**Globemaster Corridor Specific Plan  
Program EIR/EIS (SCH No. 2018091021)  
EIR-03-17**

**City of Long Beach**

**DUDEK**

NOVEMBER 2020

FIGURE 2-2

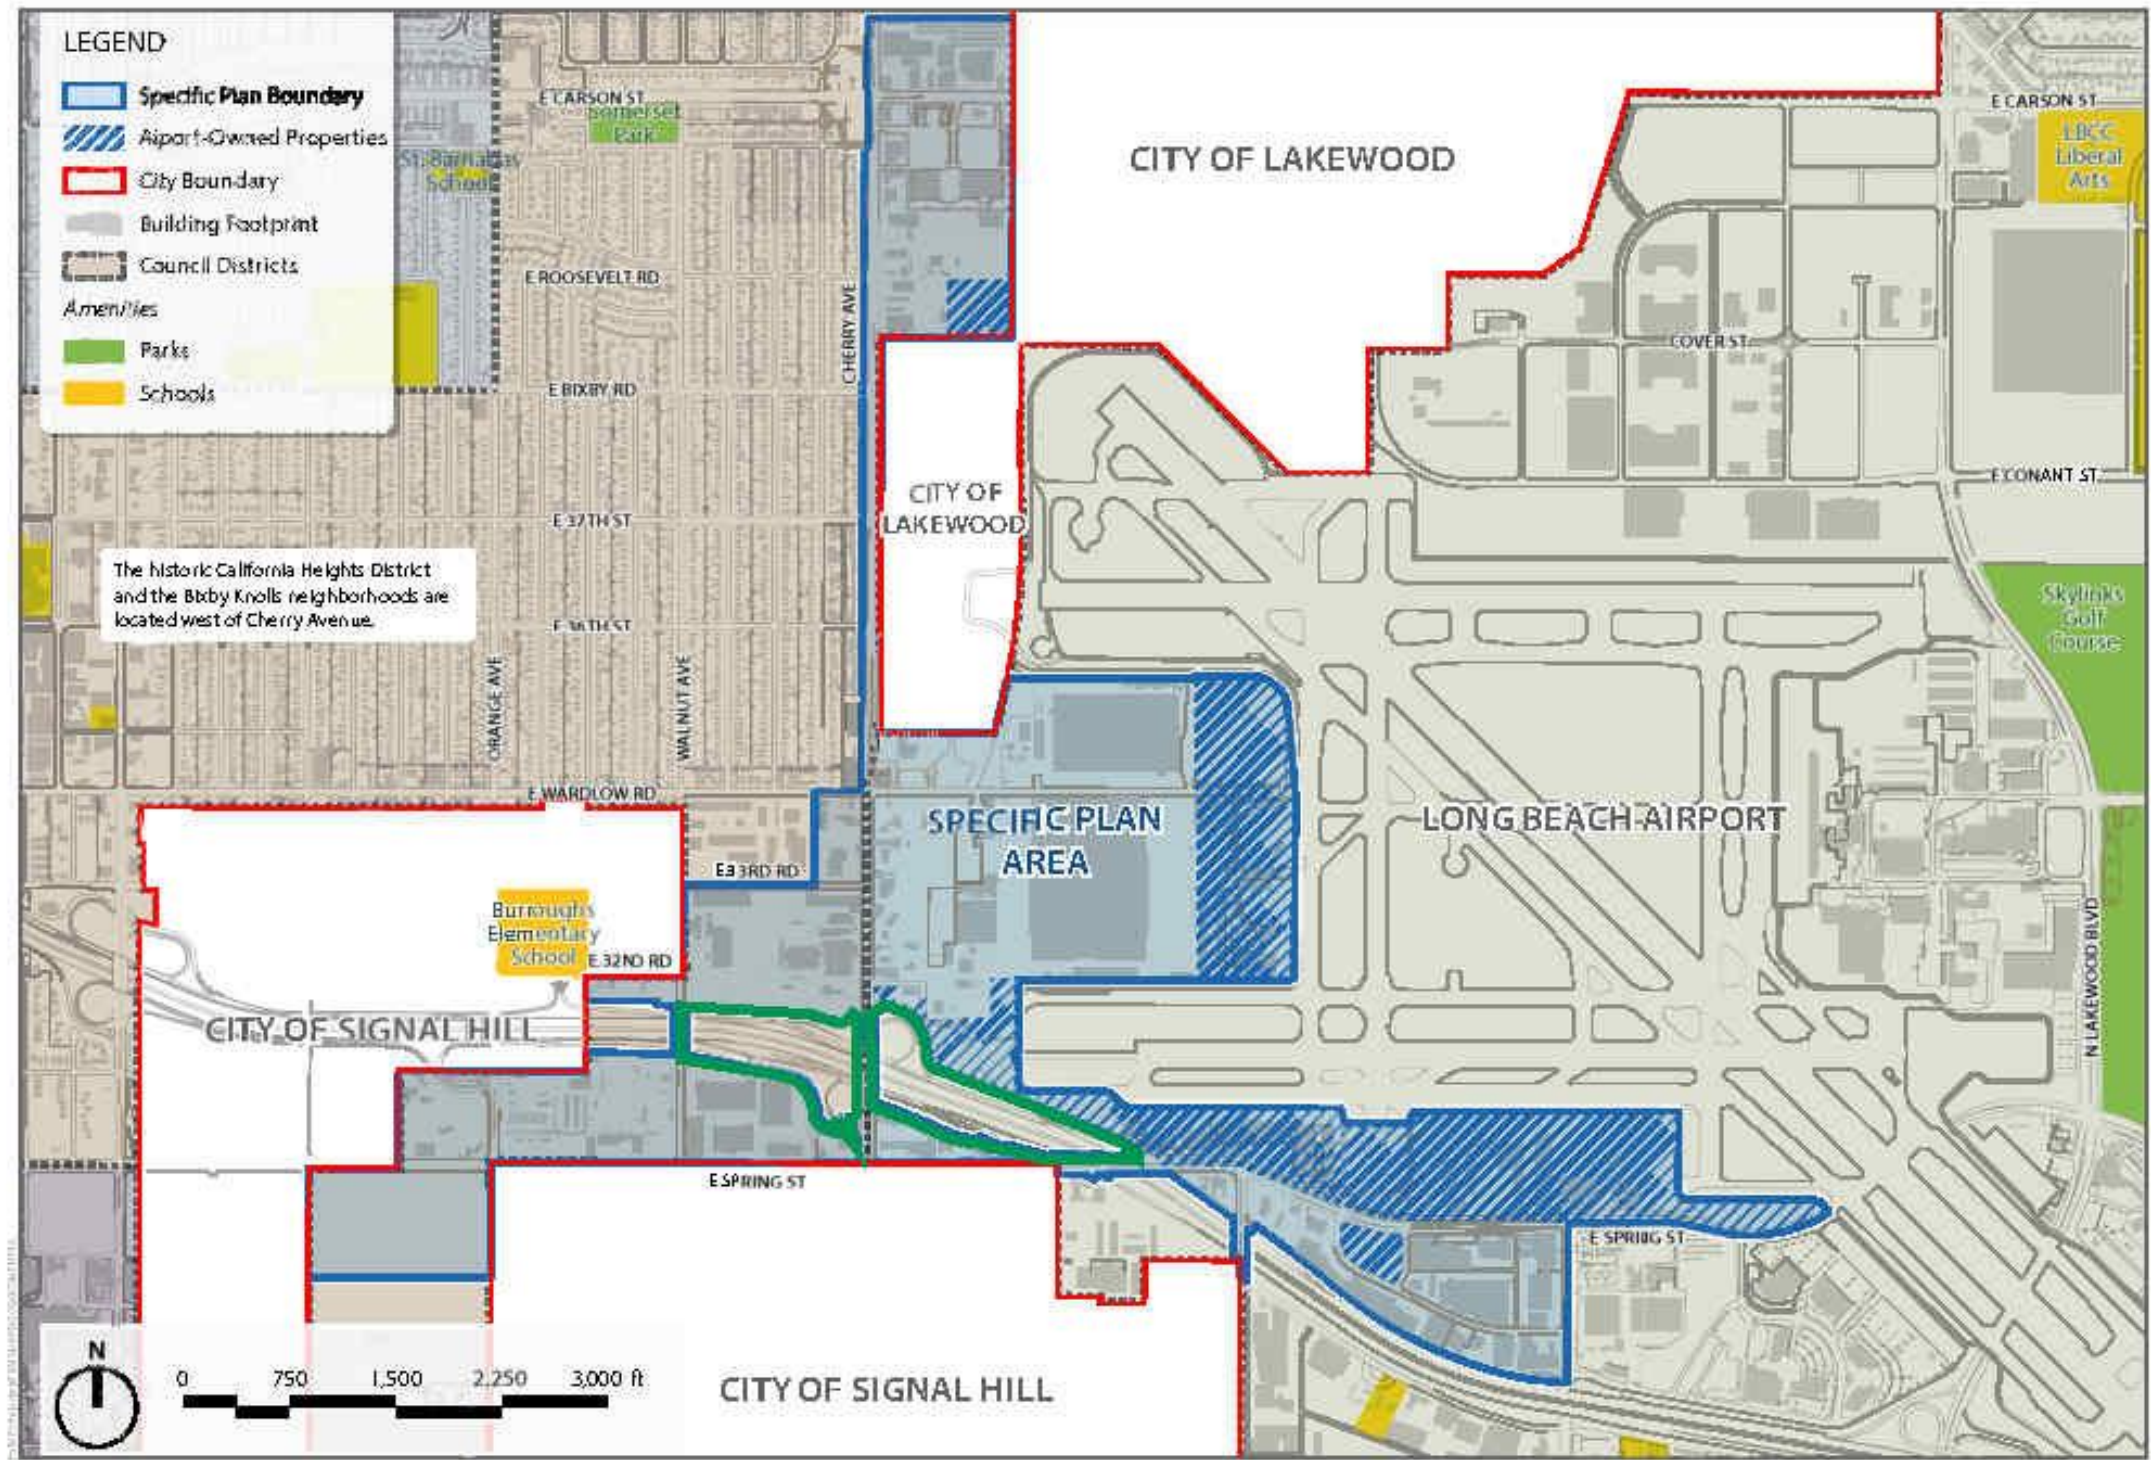
- Figure 2-2 Local Context: An Airport property is not identified in this exhibit. Assessor Parcel Number 7149-010-902 on the south side of Spring Street between Airport Way and Airport Lane is Airport-owned. Please note that this omission appears to only occur on Figure 2-2.

- 5-2** This comment is related to Figure 2-2, Local Context, in Chapter 2, Project Description, of the Draft Program Environmental Impact Report/Program Environmental Impact Statement (PEIR/PEIS). The commenter notes the airport property is not defined in this exhibit. Figure 2-2, Local Context, has been revised to include a portion of airport-owned property located south of Spring Street between Airport Way and Airport Lane that was not identified. Refer to Chapter 3, Changes to the Draft PEIR/PEIS, of this Final PEIR/PEIS.

Figure 2-2, Local Context, has been revised to include a portion of Airport-Owned Property located south of Spring Street between Airport Way and Airport Lane that was not identified in the Draft PEIR/PEIS. See the revised figure attached to the end of this chapter of the Final PEIR/PEIS. The proposed revision does not alter the analysis or conclusions presented in the Draft PEIR/PEIS.

FIGURE 2-9

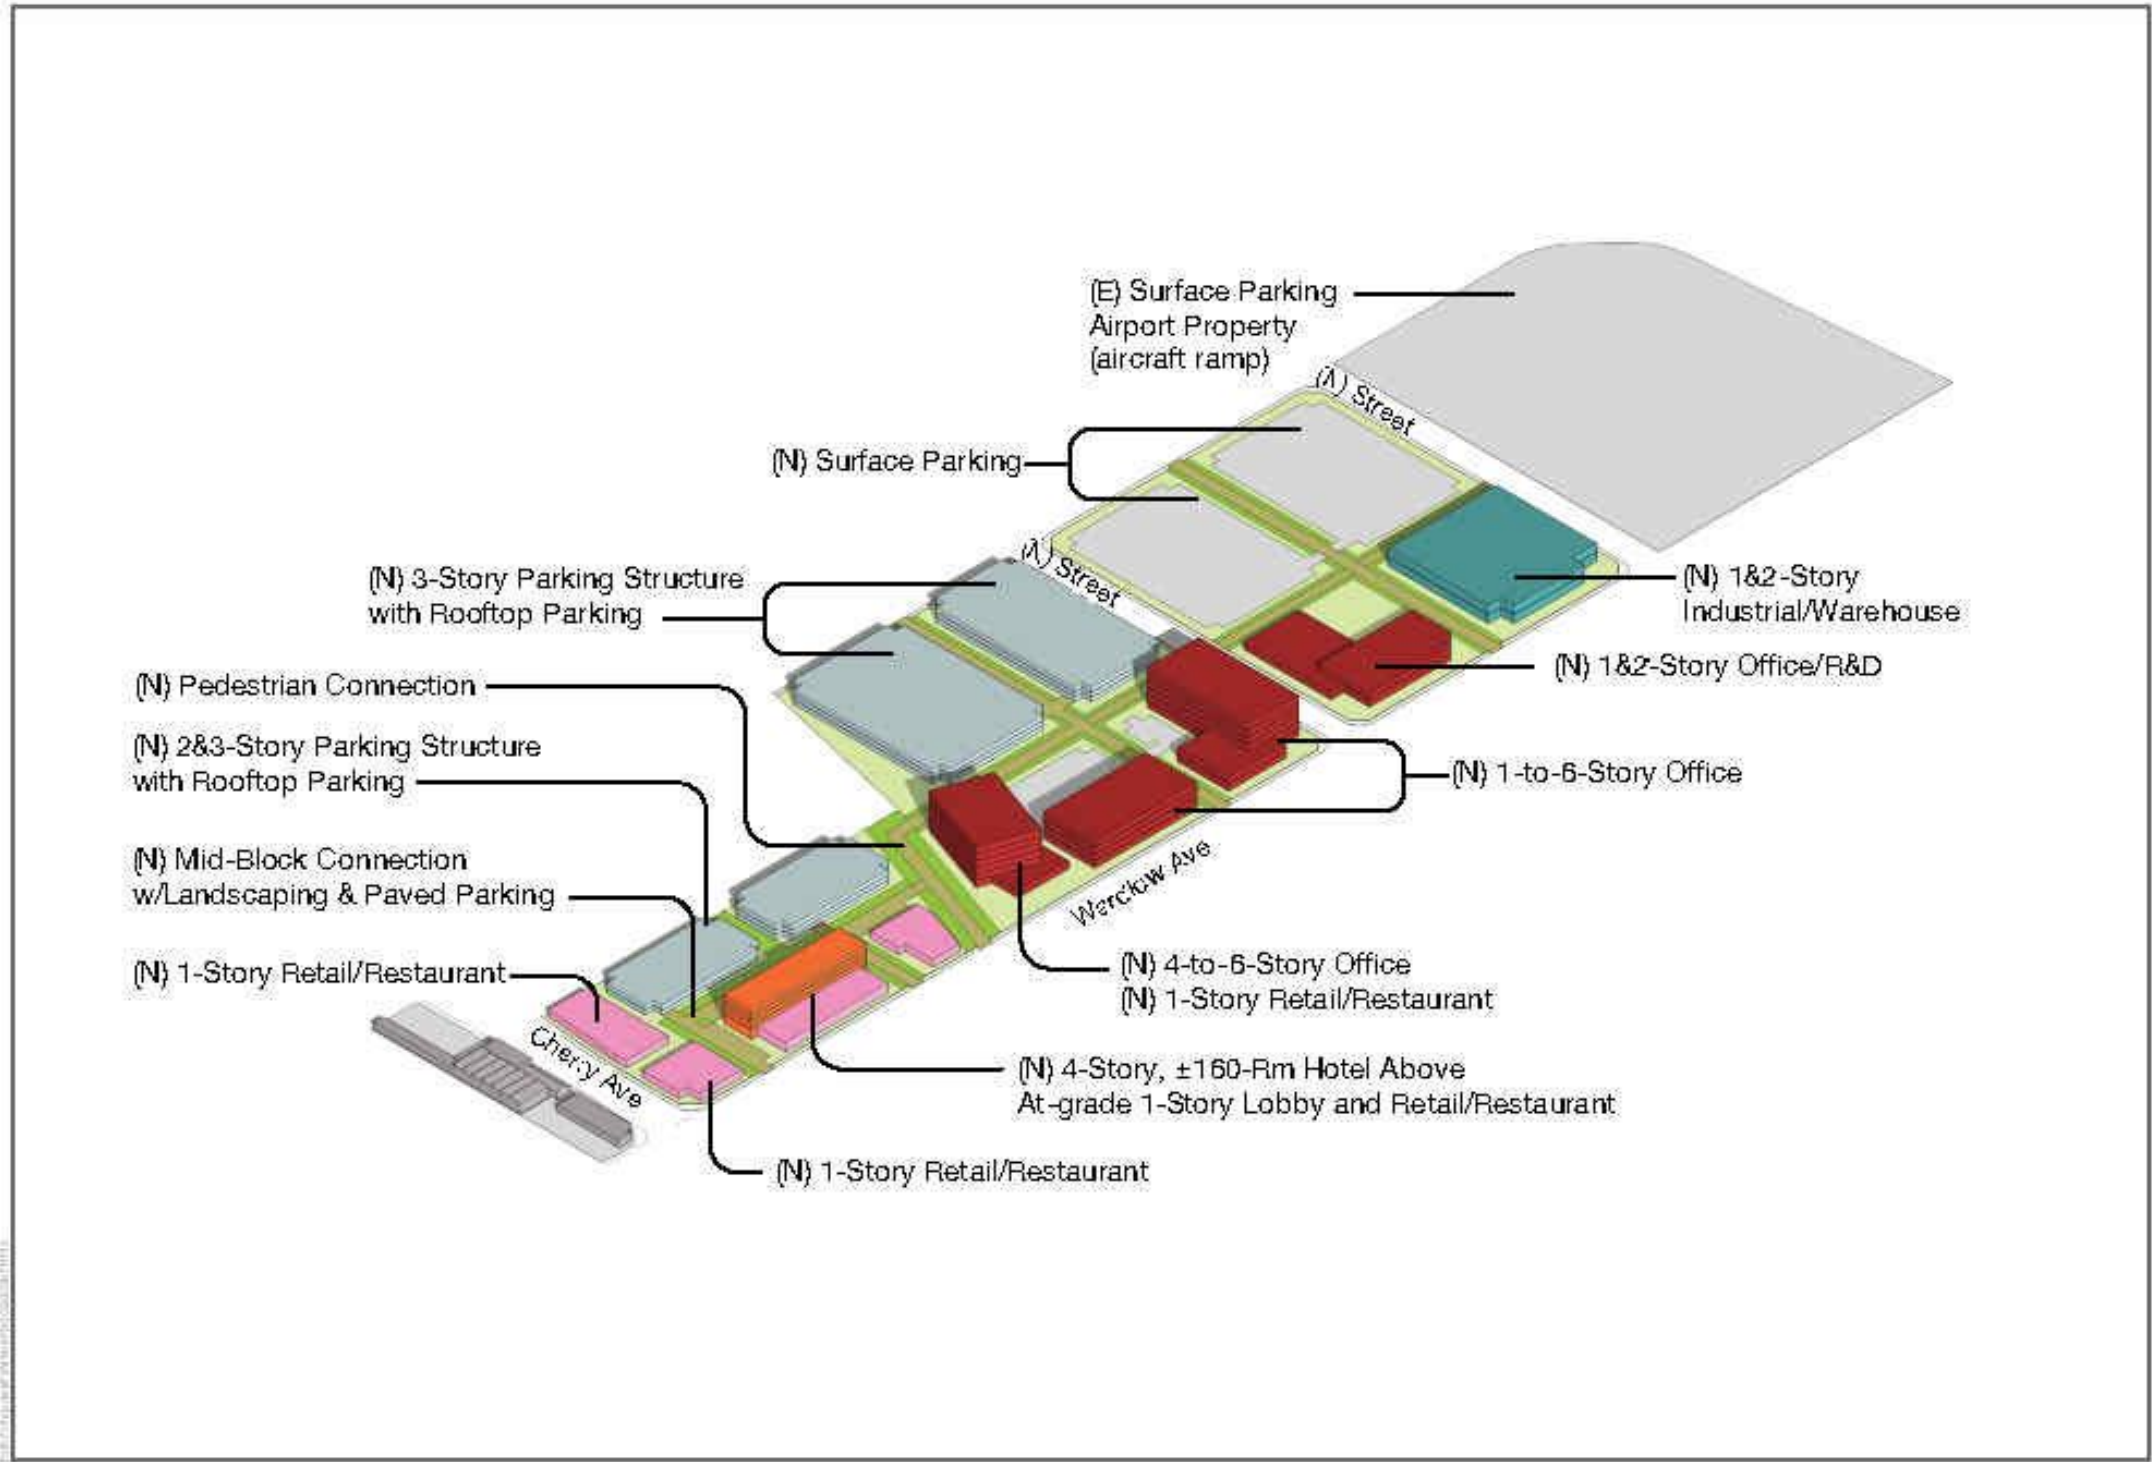
5-4
- Figure 2-8 Example Development in Business Park District: Area (E), Surface Parking, is Airport restricted property for aviation development. It would not be available to support non-aeronautical uses within the Plan Area.

- 5-5** This comment is related to Figure 2-8, Example Development in Business Park District, in Chapter 2 of the Draft PEIR/PEIS, noting Area E surface parking. The commenter states that this area is airport restricted for aviation development and it would not be available to support non-aeronautical uses. The commenter is correct in that the referenced area is marked as existing “E” surface parking and does not show new potential development because it is within the adjacent Airport District and, as previously mentioned, is reserved for property that is part of the designated airfield of the Long Beach Airport, and adjacent properties under Airport control. To clarify, this section of the figure has been revised to indicate “Airport Property (aircraft ramp)” underneath “(E) Surface Parking”. See the revision in Chapter 3, Changes to the Draft PEIR/PEIS, in this Final PEIR/PEIS.

Figure 2-8, Example Development in Business Park District, has been revised based on a comment provided by the Long Beach Airport to clarify that the area labeled as existing surface parking notes that this area is under Airport control. See the revised figure attached to the end of this chapter of the Final PEIR/PEIS. The proposed revision does not alter the analysis or conclusions presented in the Draft PEIR/PEIS.

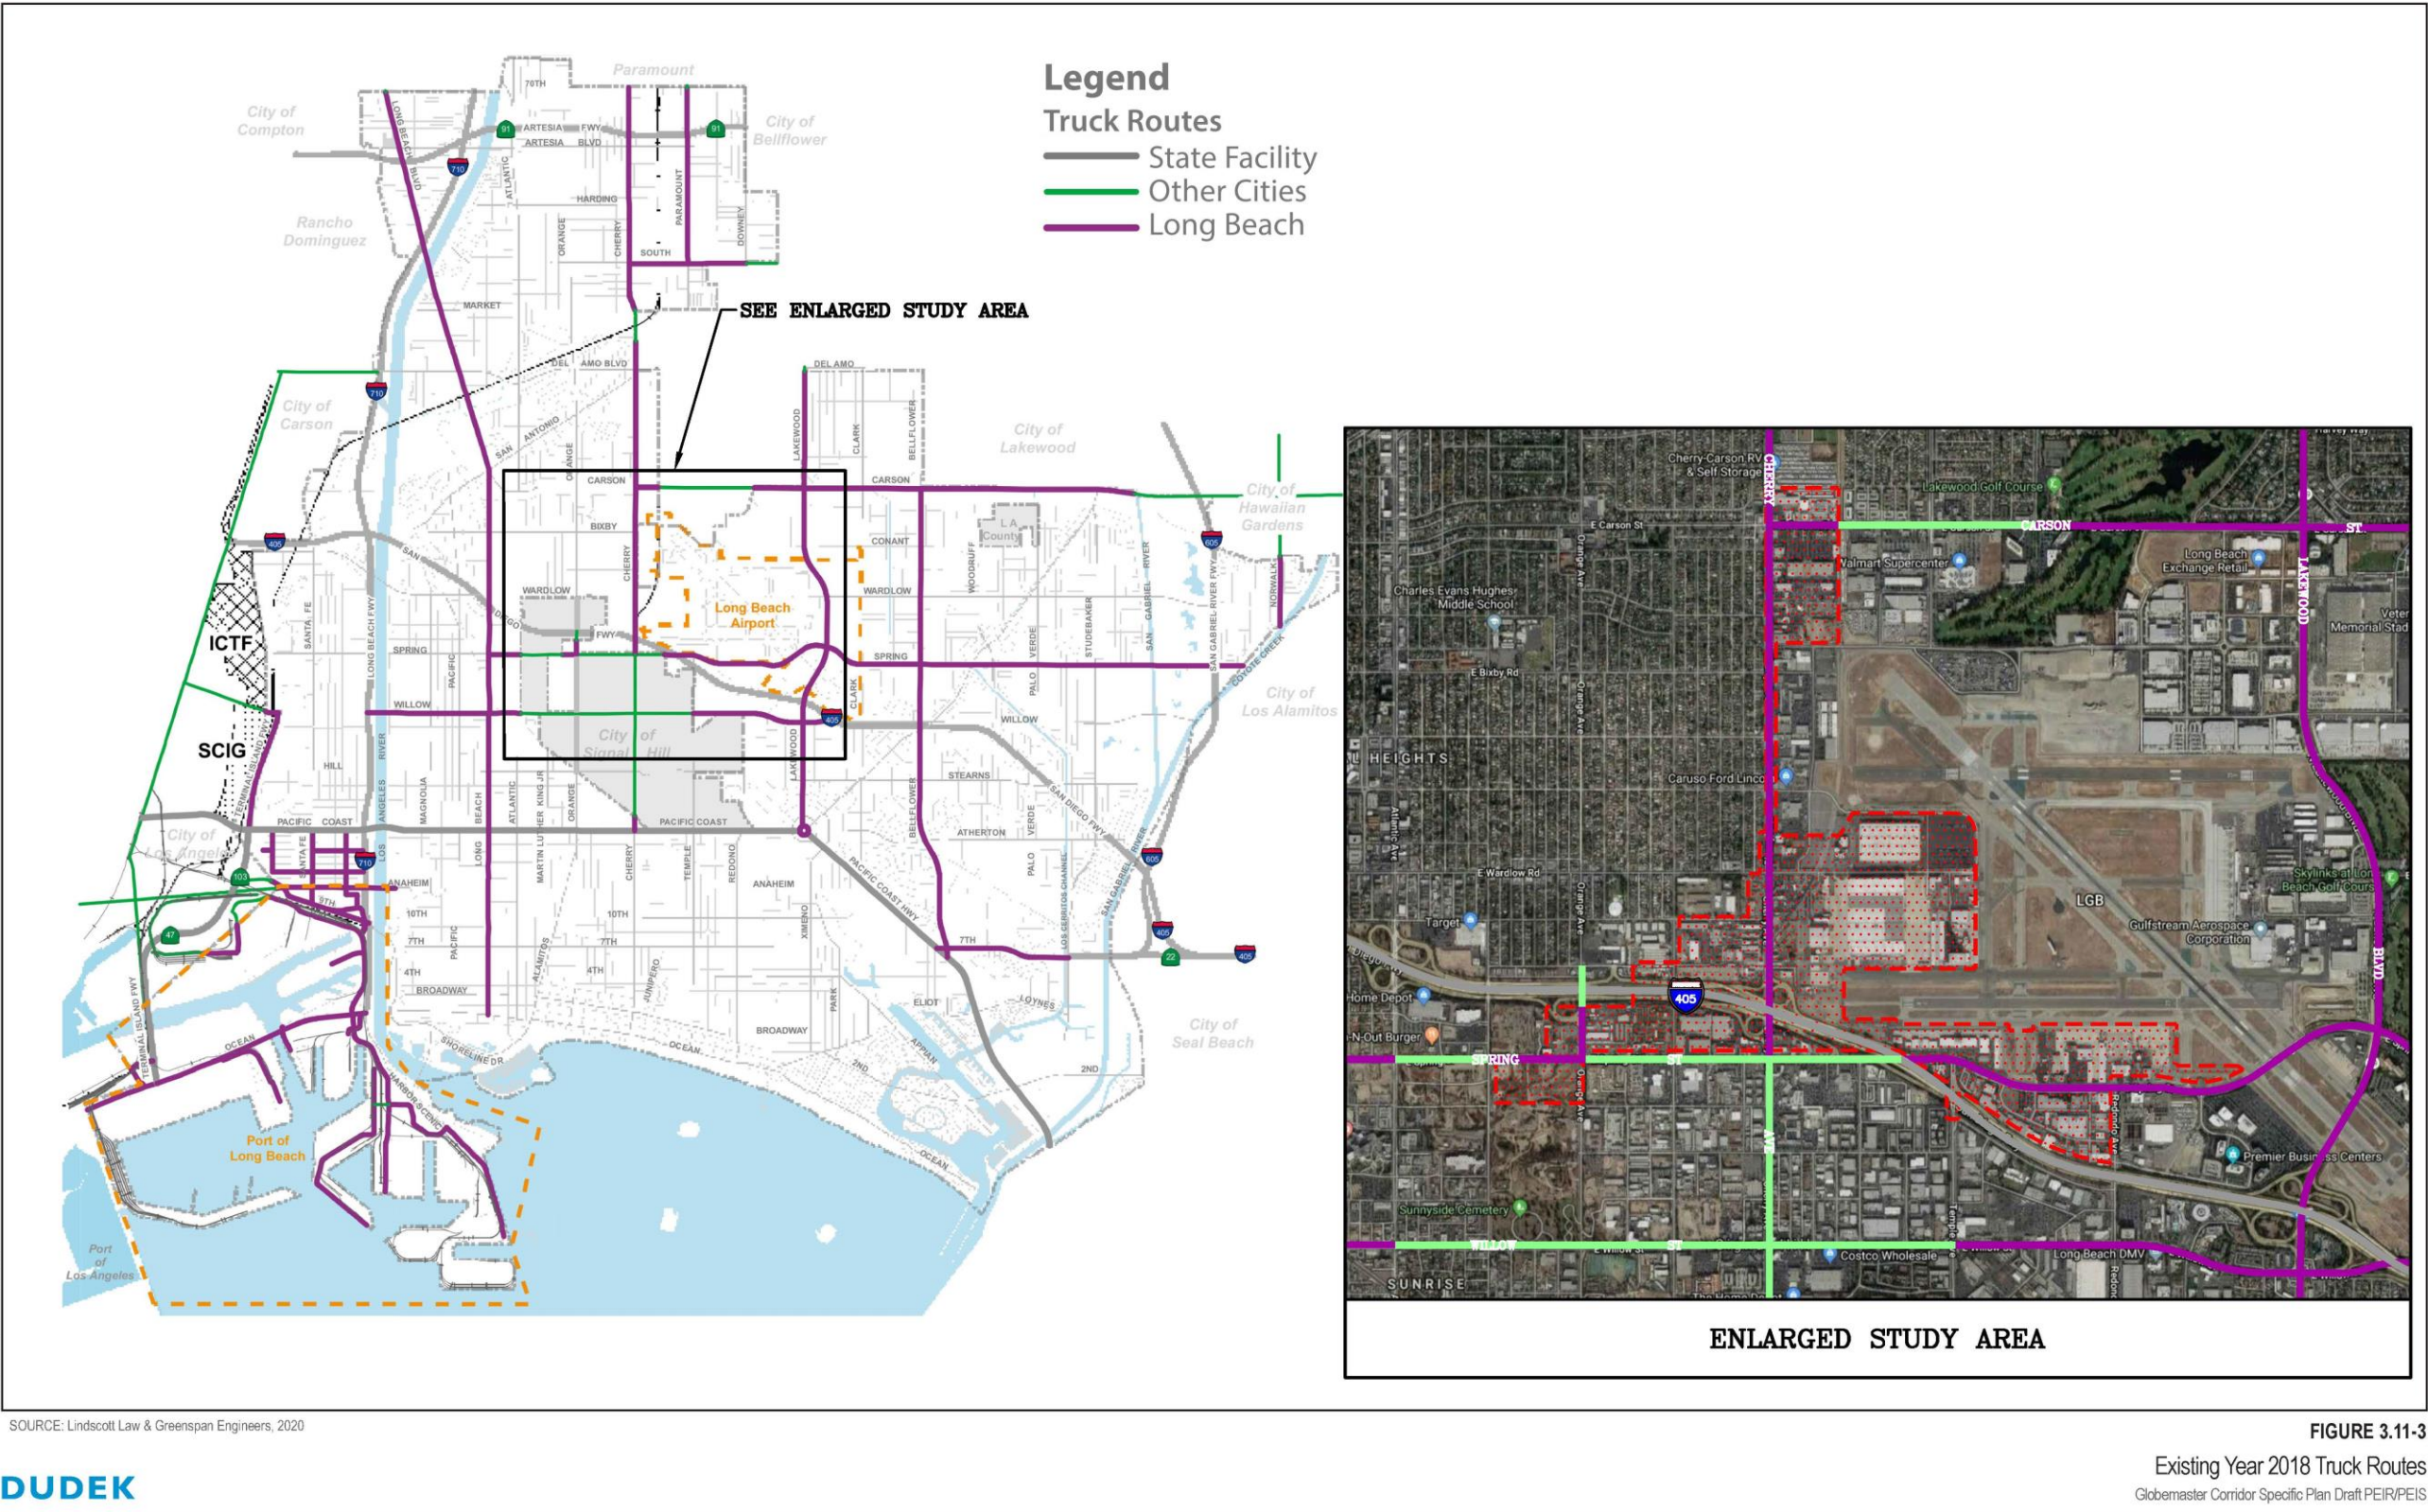
**6-8** The comment states that Orange Avenue (from Hill Street to Spring Street and from 32nd Street to Wardlow Road) is not a Truck Route within the City of Signal Hill. Figure 3.11-3, Existing Year 2018 Truck Routes, has been revised in response to this comment. See Chapter 3, Changes to the Draft PEIR/PEIS, of this Final PEIR/PEIS. This revision does not affect any of the evaluation concerning truck

Figure 3.11-3, Existing Year 2018 Truck Routes, has been revised to remove Orange Avenue as a truck route in the City of Signal Hill. See the revised figure attached to the end of this chapter of the Final PEIR/PEIS. The proposed revision does not alter the analysis or conclusions presented in the Draft PEIR/PEIS.
